**Addendum (Revision 2) to Remedial Action Options Report (RAOR)  
and Pre-Design Sampling Work Plan - Connell Aluminum Properties, LLC  
Former Koppers Tar Plant and Wabash Alloys Site  
9100 S. 5<sup>th</sup> Avenue, Oak Creek, WI 53154  
BRRTS# 02-41-553761, FID#241379050  
Connell VPLE BRRTS #:06-41-560068**

September 28, 2021

**City of Oak Creek Utility Corridor Lot 1  
9170 South 5<sup>th</sup> Avenue, Oak Creek, WI 53154  
BRRTS#: 02-41-561425, FID #:341074470  
VPLE BRRTS#: 06-41-561426**

**FIGURE 5**  
**FIGURE 8 (REV. RAOR REPORT)**

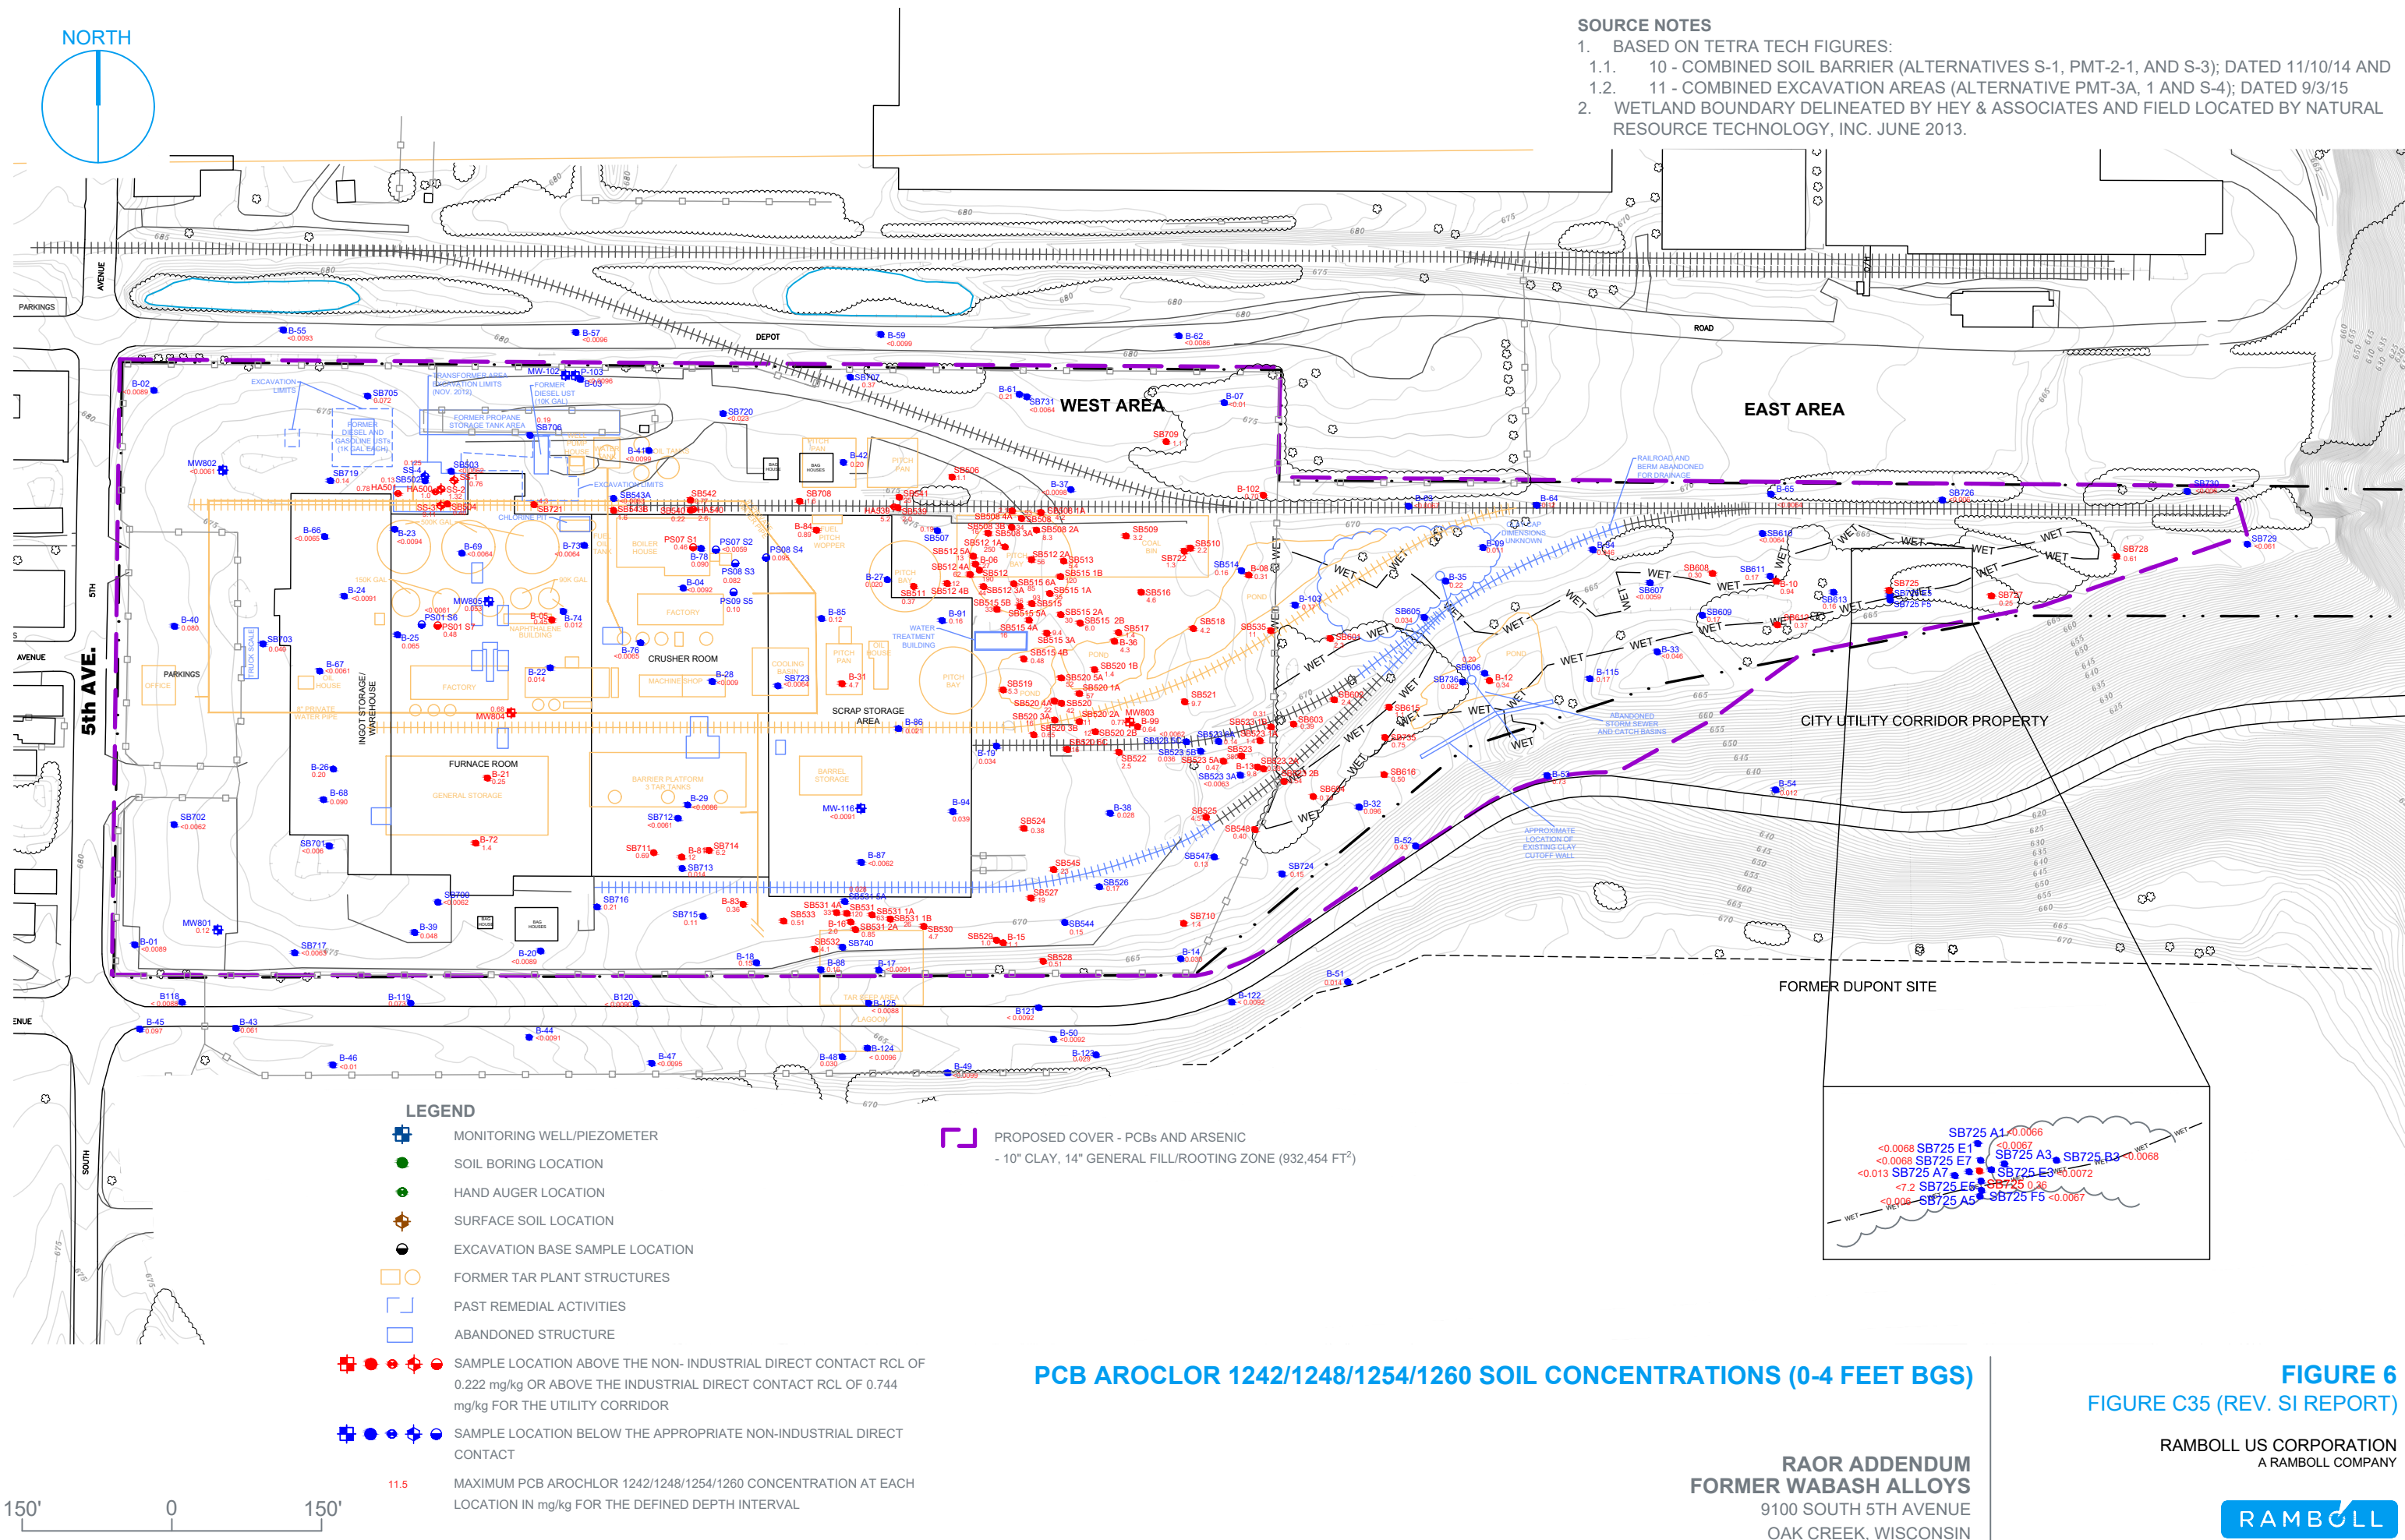
- Figure 5 – Revised RAOR Figure 8 - PCB and Arsenic Soil Barrier (Alternative S-3) for purposes of showing the revised estimated cap extent in both the western and eastern areas.
- Figure 6 – Revised Figure C35 SI Report – PCB Aroclor 1242/1248/1254/1260 Soil Concentrations (0-4 feet bgs) for purposes of showing PCB sampling results and proposed cap extents.
- Figure 7 – Revised Figure C1 SI Report – Arsenic Soil Concentrations (0-4 ft bgs) for purposes of showing arsenic sampling results and proposed cap extents.

As shown in the revised figures, the PCB and Arsenic Soil Barrier will extend to the property boundaries at the western extent due to the widespread contamination. Any future management of soils would need to follow requirements of Wisconsin Administrative Code ch. NR 718.

**FIGURE 8**

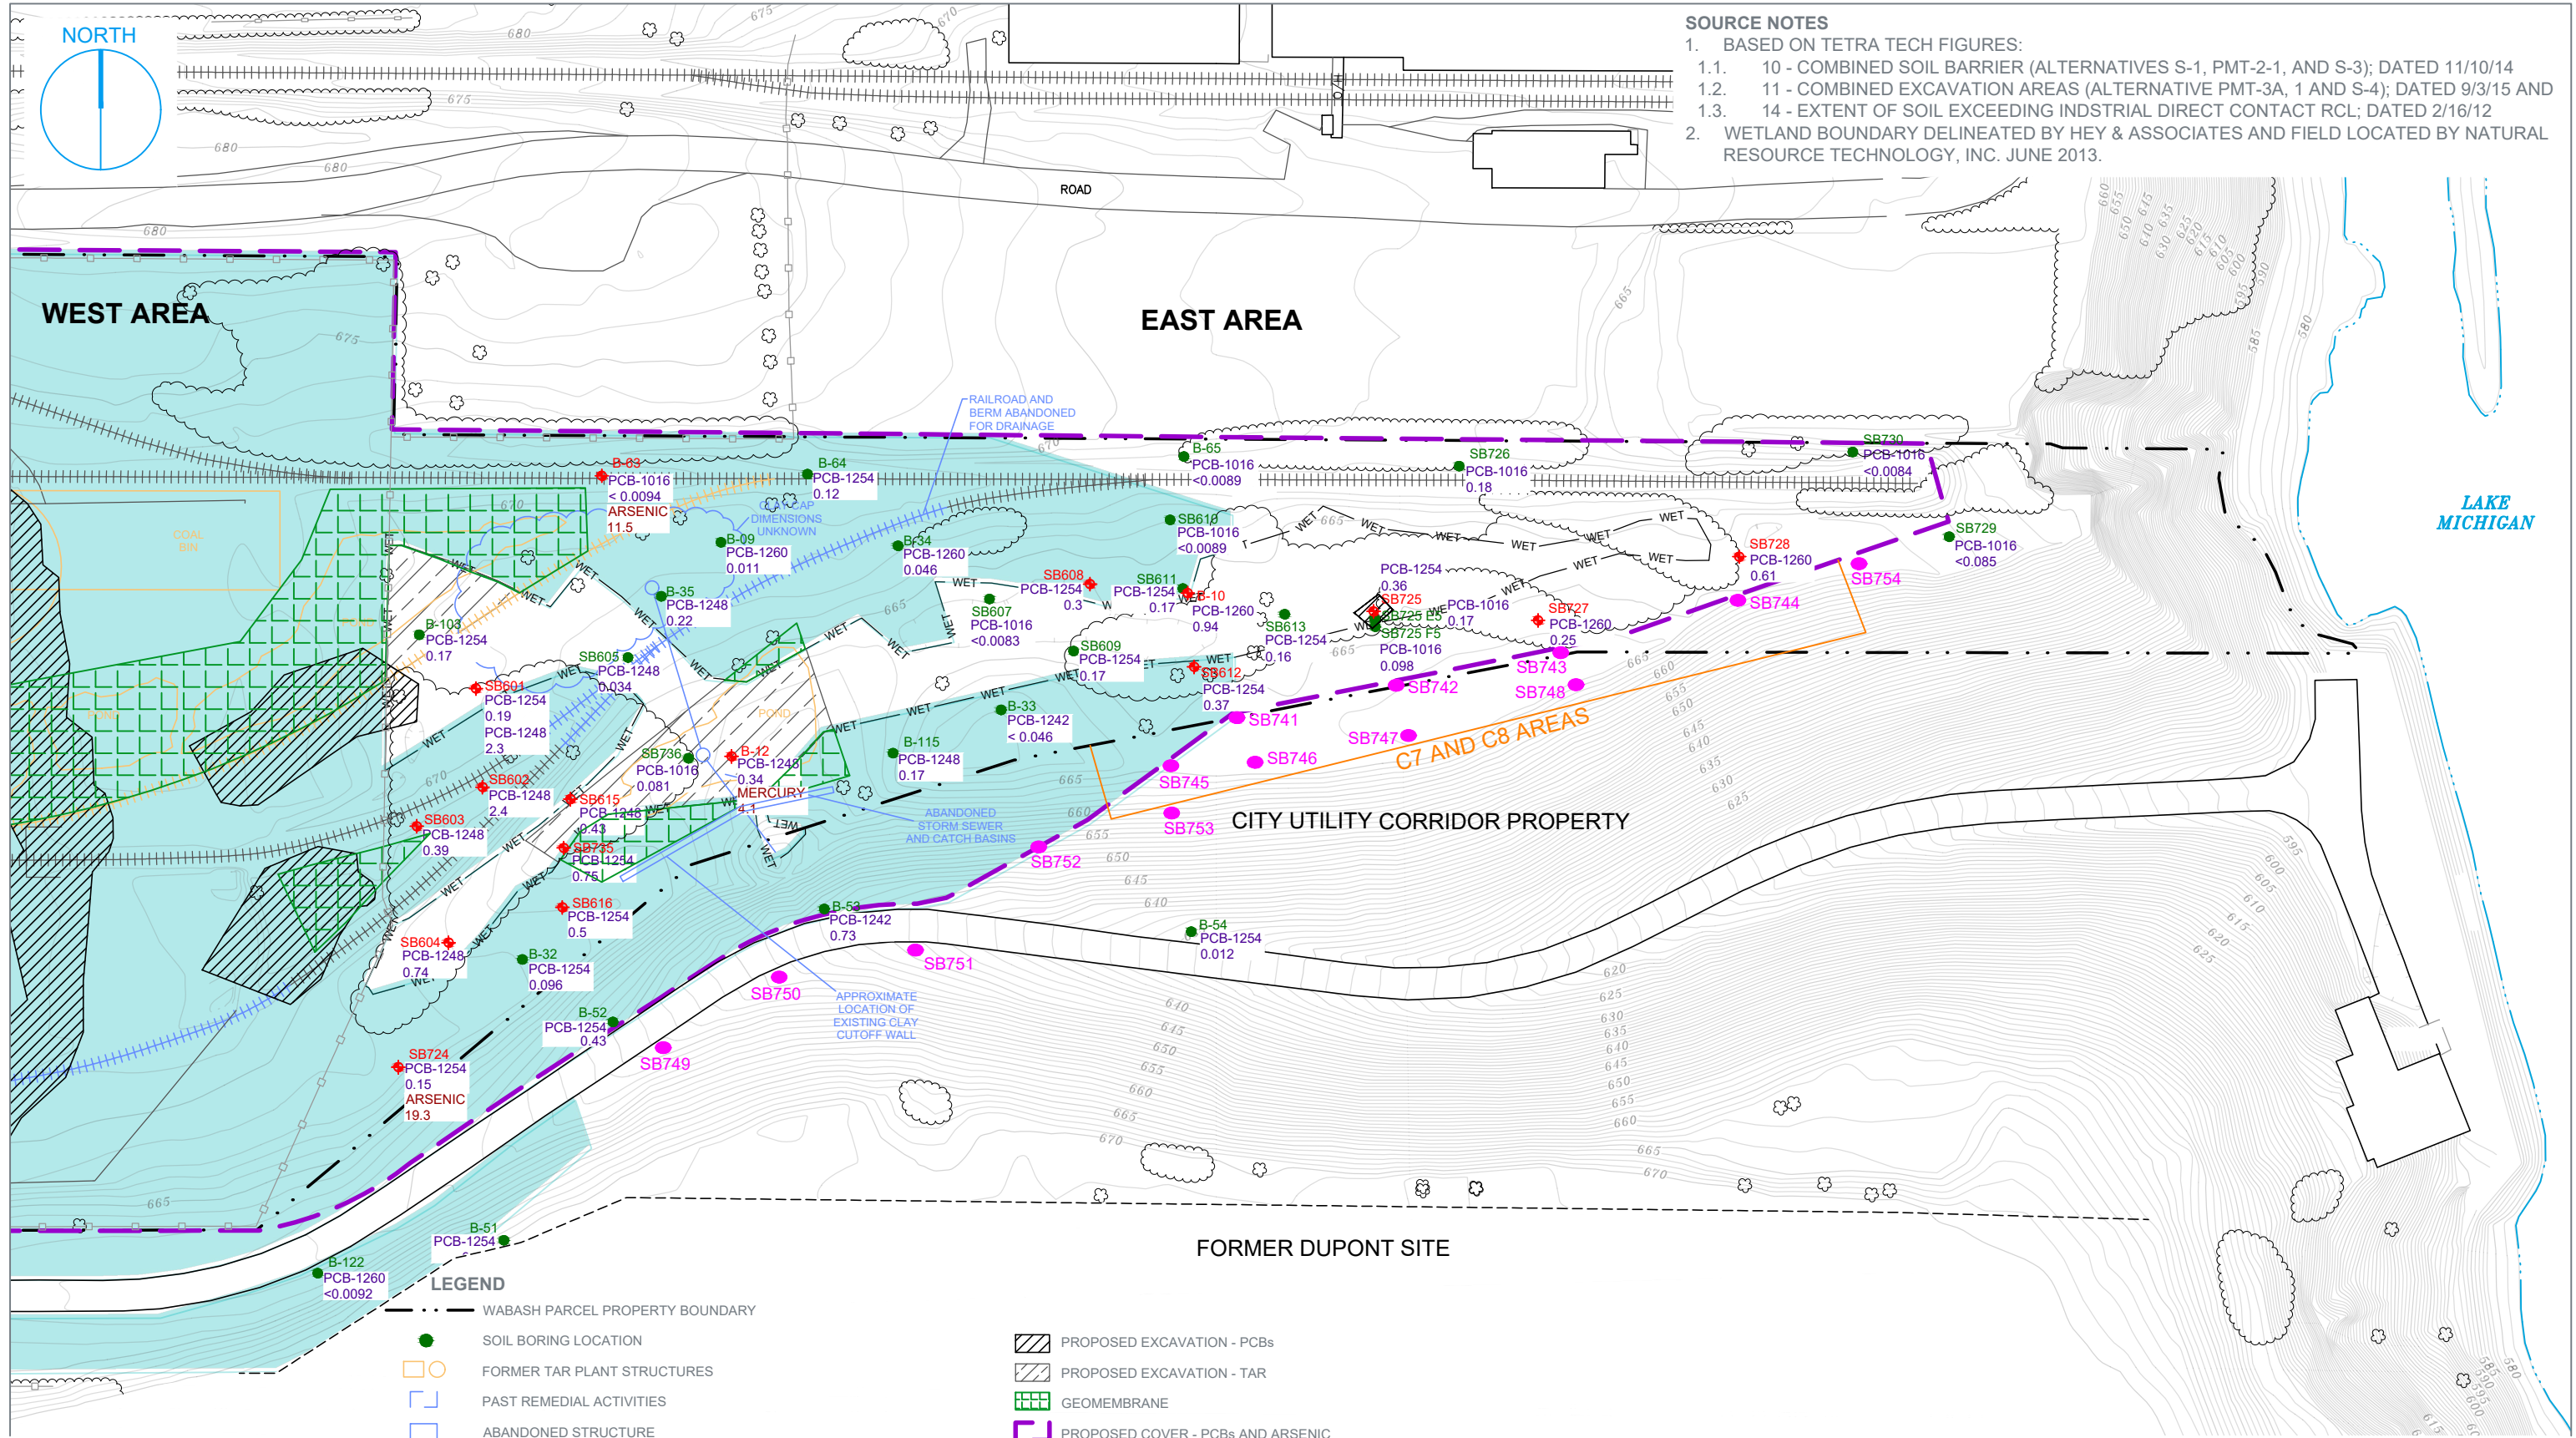
Ramboll has prepared a new figure (Figure 8) to illustrate the additional proposed capping extent in the eastern area, to include both wetland and non-wetland areas that exceed respective non-industrial RCLs.

- Figure 8 – PCB and Arsenic Soil Barrier – East Area for purposes of showing the additional proposed cap extent. The additional pre-design sampling locations related to comments C7 and C8 and eastern City corridor are shown (14 borings labeled SB741 to SB754). Nine (9) of the sampling locations are proposed to be performed on the City Utility Corridor property, and as such, access for these will be requested from the City. WDNR comments C1 through C6 are not applicable as the cap is being extended to the property boundary or beyond to the City property in these areas, and largely coincides with the proposed cover for PAHs (Beazer plans).
